Re-Roofing and Associated Work at Hickory Tree

ADDENDUM #1

August 4, 2015

PROJECT: RE-ROOFING AND ASSOCIATED WORK AT HICKORY TREE

Attachment: SK-1

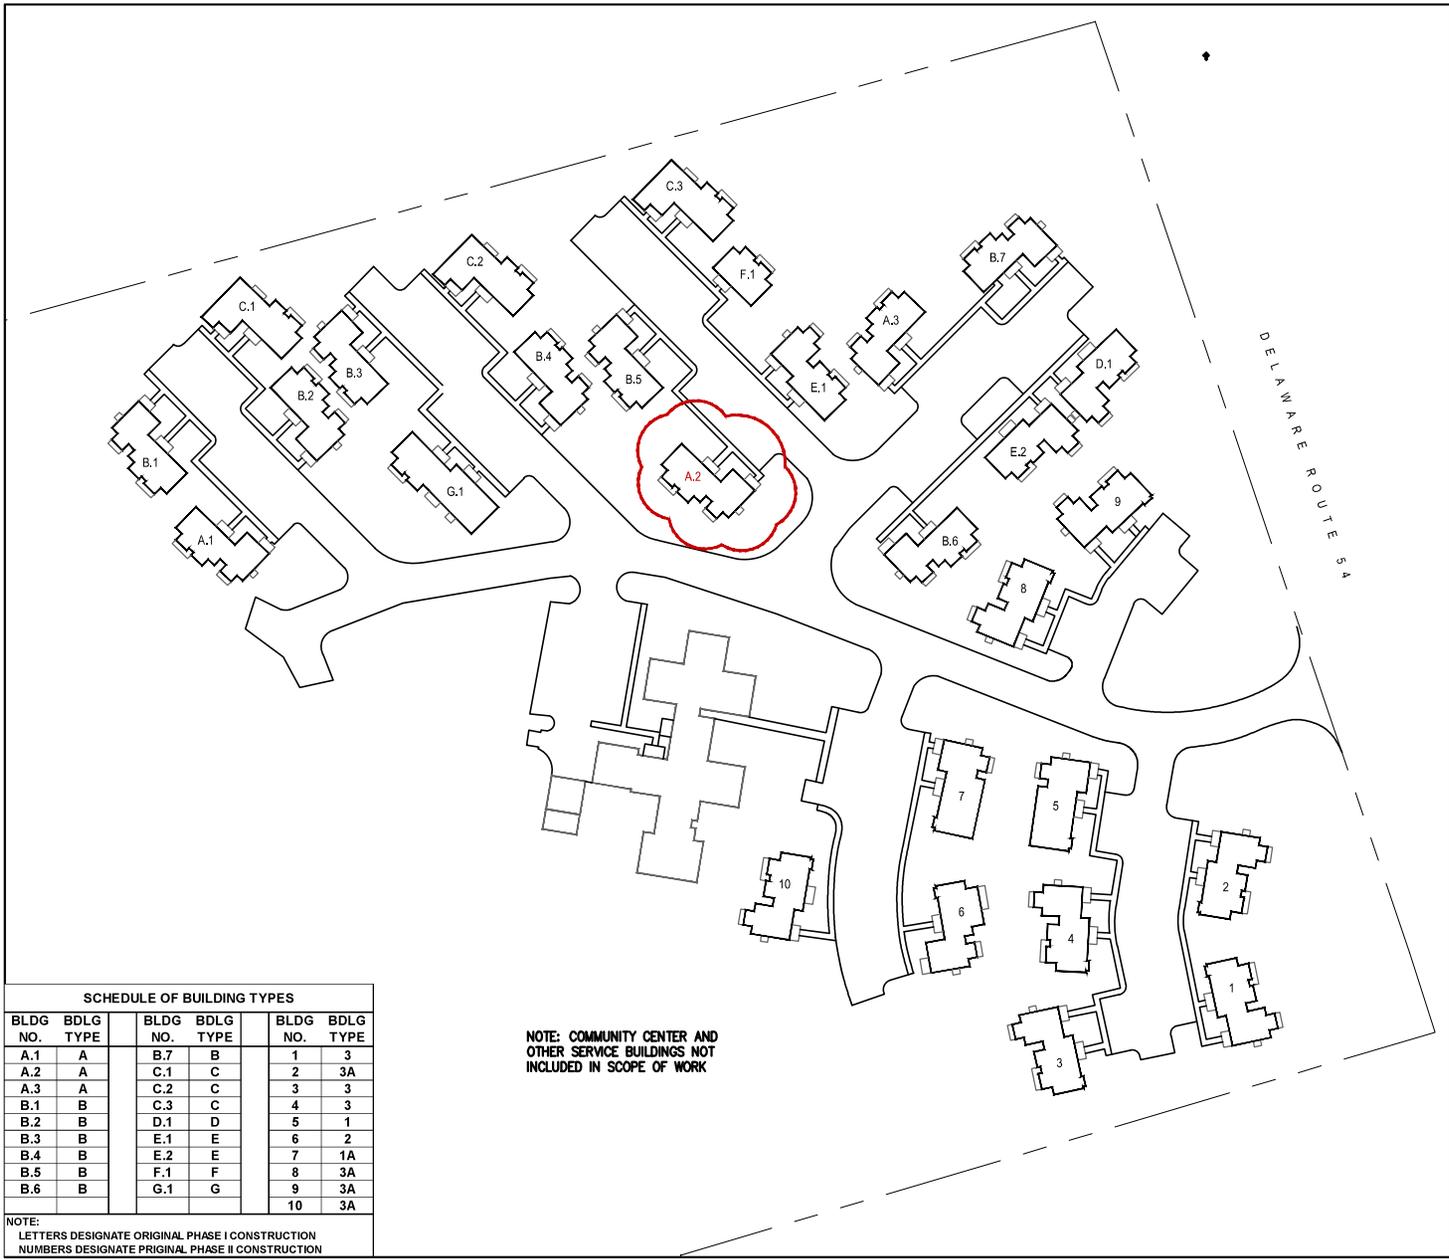
AD 1.1 Q: Building style A.2 does not show up on the print map. Are we removing the Plywood and shingles etc. on all 28 Buildings on site?

A: See attached sketch showing the location of building A.2. All 28 apartment buildings are included in this scope of work.
